# URBAN DESIGN COMMISSION APPLICATION CITY OF MADISON

1. Project Address: Phase II-800 North Block, East Washington Avenue (802, 854; Block 143)  
Project Title (if any): the Galaxie

Owner: Otto Gebhardt, Gebhardt Development  
Project Name: the Galaxie Phase II  
Purpose: UDC Design Progression Submission

# THE GALAXIE - PHASE II

NORTH PATERSON STREET FACADE

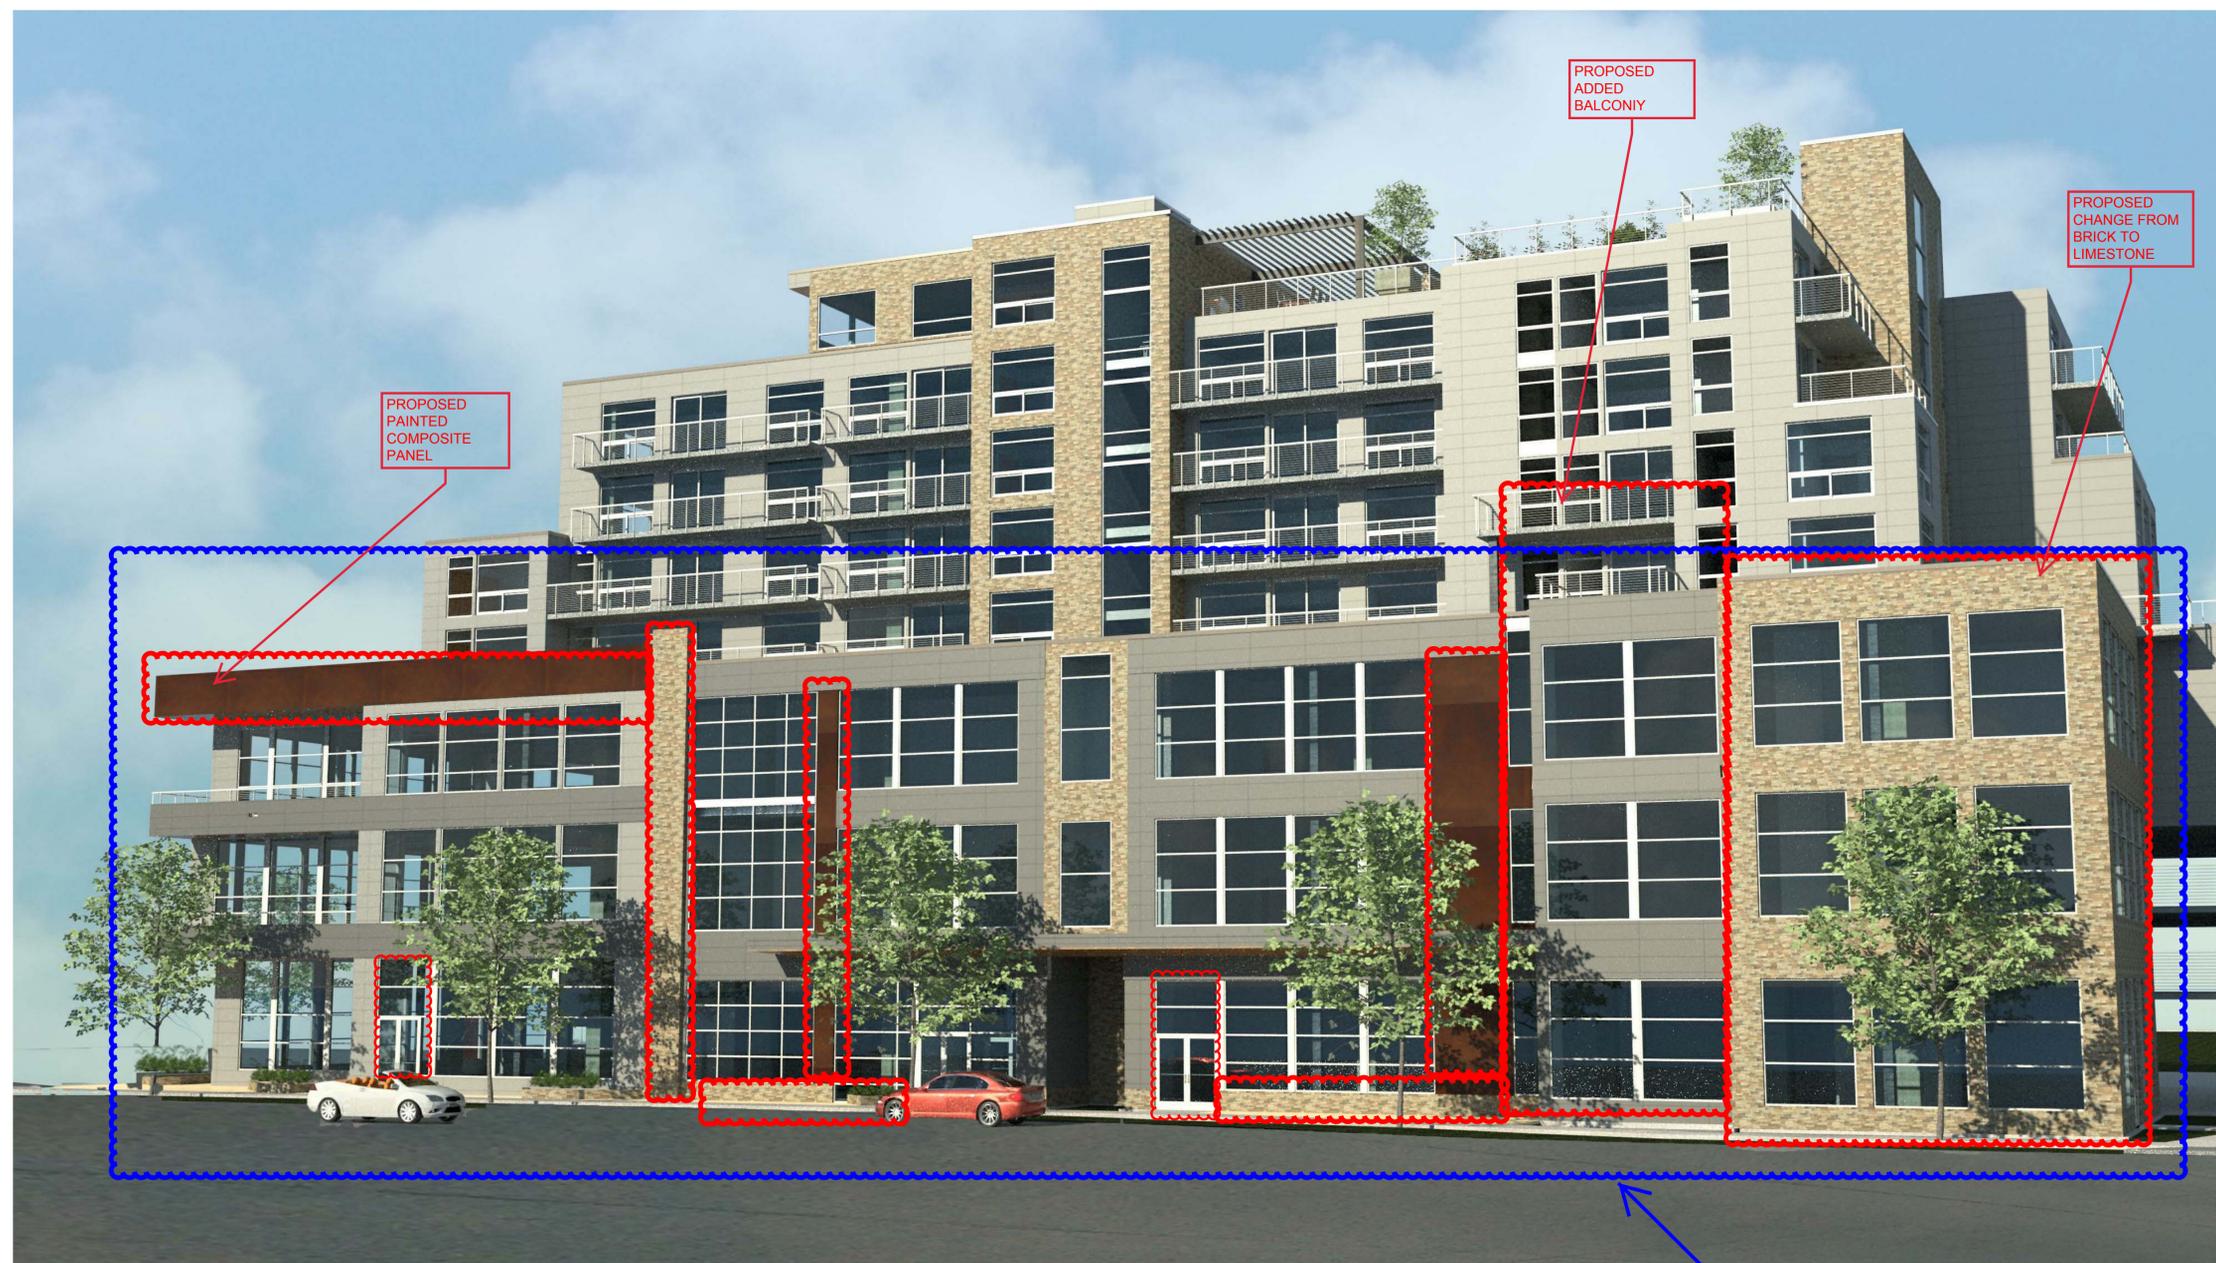
PROPOSED STOREFRONT  
REDESIGN W/ 1 PIECE  
ANNOXIDIZED ALUMINUM  
BRAKE METAL JAMB
